Central Valley Regional Water Quality Control Board

NOTICE OF APPLICABILITY WATER QUALITY ORDER 2015-0121-DWQ GENERAL WASTE DISCHARGE REQUIREMENTS FOR COMPOSTING OPERATIONS COMPOST SOLUTIONS, INC. COMPOST SOLUTIONS, INC. COMPOST FACILITY GLENN COUNTY

STAFF MEMORANDUM

SUBJECT: **APPLICABILITY OF COVERAGE UNDER STATE WATER RESOURCES CONTROL BOARD WATER QUALITY ORDER 2015-0121-DWQ, COMPOST SOLUTIONS, INC., COMPOST FACILITY, GLENN COUNTY**

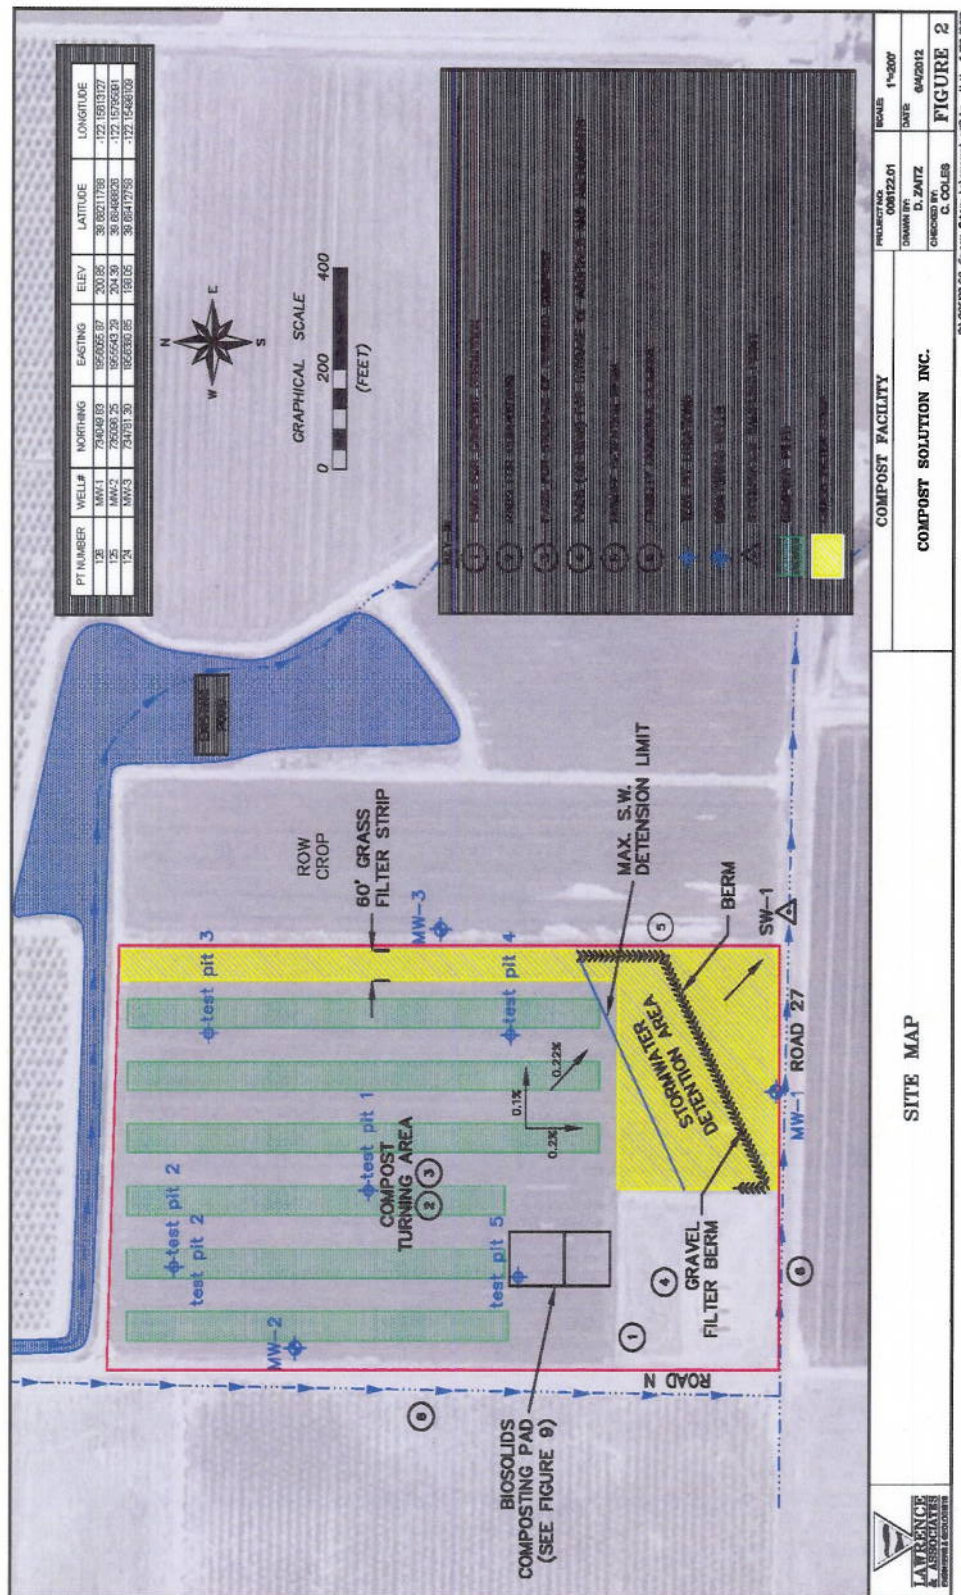
Staff conducted a site visit in March 2016 to confirm the Facility was adhering to the winterization plan outlined in the June 2012 Technical Report (resubmitted in July 2016). Approximately 60,000 cubic yards of compost were at the Facility. The compost piles were not covered as per the Technical Report. It appeared that the Discharger has been composting year-round. Furthermore, some improvements to the storm water management system have been implemented such as the trough to collect runoff and evenly discharge to the irrigated detention area. See Attachment C for photographs. Staff also noted a Dense-Out® Vibratory AIR Separator was located at the Facility, presumably to address previously noted concerns of feedstock and compost with non-decomposable materials. While the working surface meets the requirements of the General Order, staff remains concerned that storm water is not properly managed and may continue to impact water quality at and near the Facility. Hence, continuation of the semi-annual groundwater monitoring program is warranted.

ATTACHMENT B

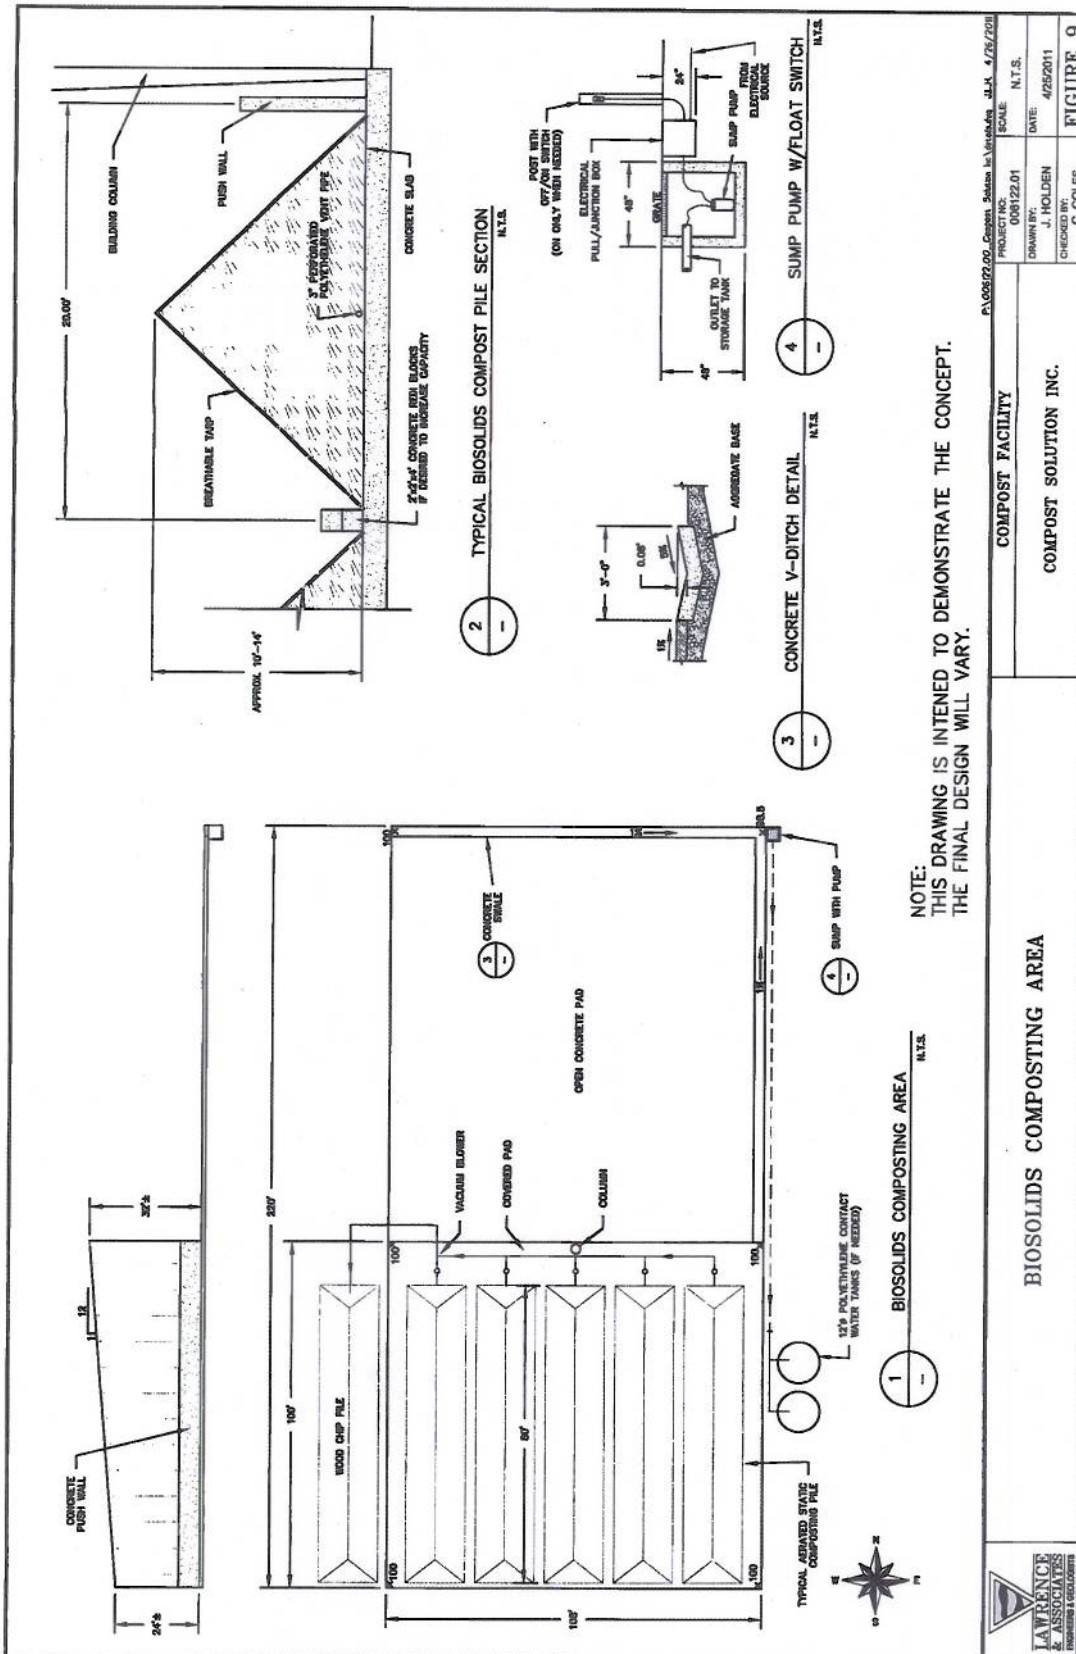
In general, water detention is provided by an unlined, gravel berm in the southeast corner of the facility as shown on the site map in Attachment A. The berm is designed to detain storm water runoff within a grass filter strip for the purpose of peak-flow and sediment control. The storm water detention area is not considered to be a retention leachate pond. Because historically the agricultural and green waste were composted seasonally, the Discharger has considered the Facility to be a closed system during the operating season, with no water running on or discharging off the property. However, because the Technical Report proposes year-around composting, improvements are needed for the storm water detection at the facility.

The working surface in which the composting occurs is one to ten feet above the surrounding properties. Therefore, there is no run-on. The down slope edges of the property to the east and south have 12-foot wide roads that prevent uncontrolled runoff onto adjacent properties. Runoff flows to the southeast corner of the property, where it flows into a roadside ditch along County Road 27. A site specific sampling point for storm/surface water (SW-1) is shown on the site map in Attachment A.
